Sub: Draft Modification Sheet for Provision of BP Pressure drop Audio Visual Indication in Banker Electric locomotives.

DRAFT MODIFICATION SHEET No. RDSO/2025/EL/MS/XXXX Rev. '00', Dated----

1.0 Title: Modification sheet for provision of BP pressure drop audio visual indication in Banker Electric Locomotives.

9.0 Modification Drawing: The electrical schematic circuit diagram of aforesaid circuit Modification has been indicated in Figure-1 (enclosed).

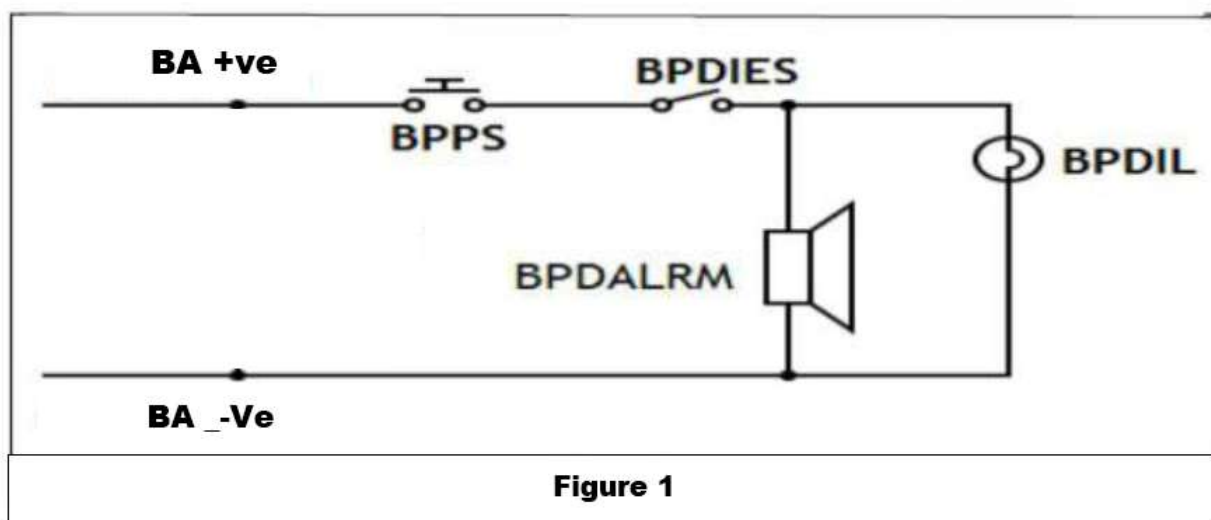
4.1 A pressure switch shall be mounted suitably in cab-1 and to be connected with BP pneumatic Line. Tapping from BP pneumatic line for different make of brake system may be taken from cab-1 BP gauge pipe line below the driver desk. The electrical circuit schematic shown in figure-1 is for indicative purpose only and applicable for modification in both cab of locomotives. The 110V DC Battery supply shall be taken from cab-1 of 3-phase electric locomotives with terminals 2095(+ve) & 2050(-ve) and for conventional locomotives cab-1 SB terminals 003(+ve) & B(-ve). Sheds may carry out above said modification in locomotives based upon extant local conditions and their requirement of banker Locomotive operation.

4.2 A BPDIES (toggle switch) has been provided in both cab to enable/disable this modification when locomotive work in Banking/non-banking service. When Loco pilot of lead locomotive drops BP in lead locomotive, this BP reduction will be sensed by BPPS pressure switch in banker locomotive and BPPS closes the circuit on BP dropping to 4.6 Kg/cm². This will make BPDALRM (BP drop alarm) to sound and BPDIL (BP drop indication lamp) to glow. Location of BPDIL, BPDALRM and BPDIES should be in combined arrangement and should be mounted in front of loco pilot in each cab as shown in Fig.3.
